2019 SMP Package V (Bertetti., Fedora)  
Solicitation Number: CO-00205  
Job No.: 18-5015

**ADDENDUM 1**  
August 14, 2018

**CHANGES TO THE PLANS**

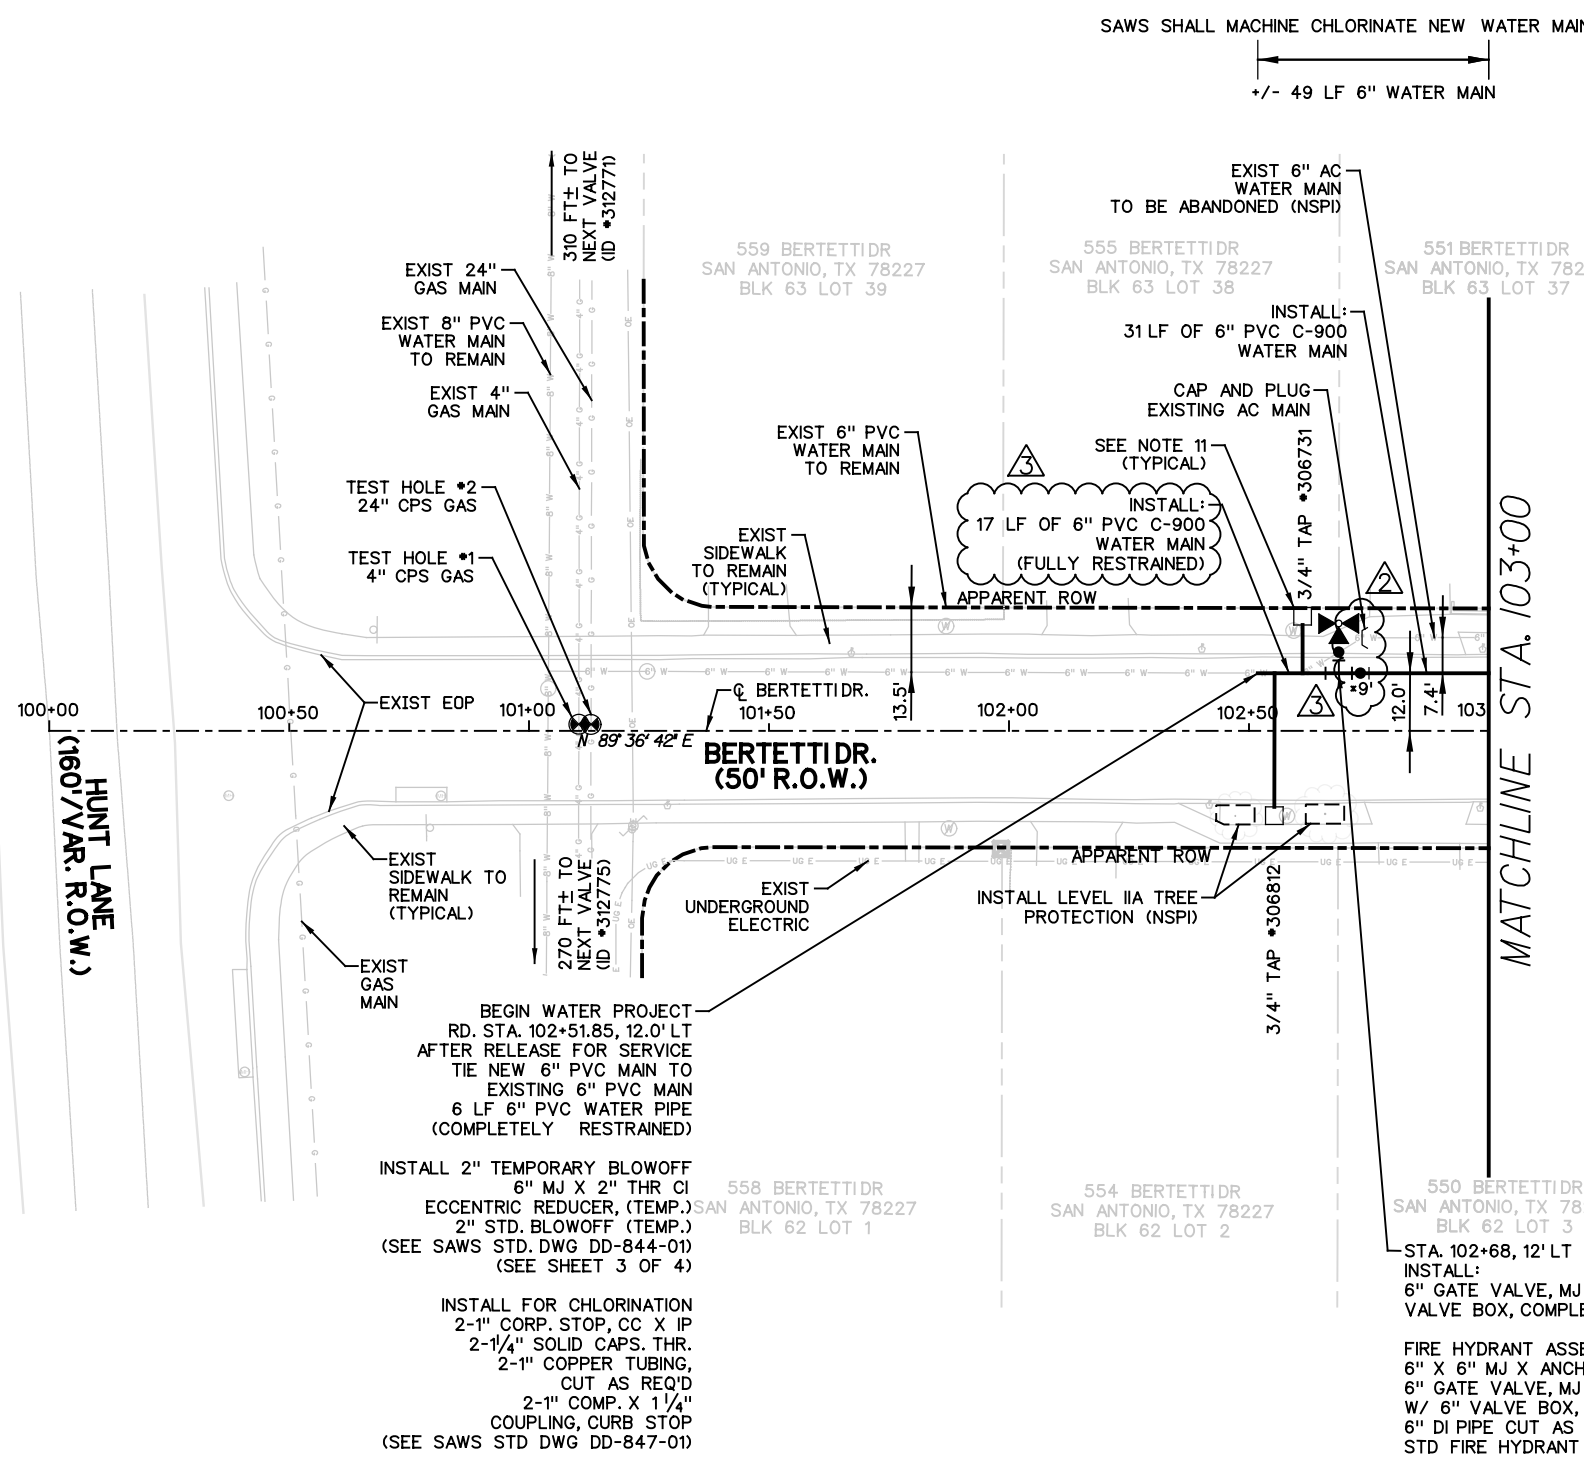
- 1. Adjustment to traffic control note, sheet 4 of 33
- 2. Adjustment to cap/plug locations, sheets 17, 21, 22 of 33
- 3. Adjustment to restrained lengths all water plan sheets
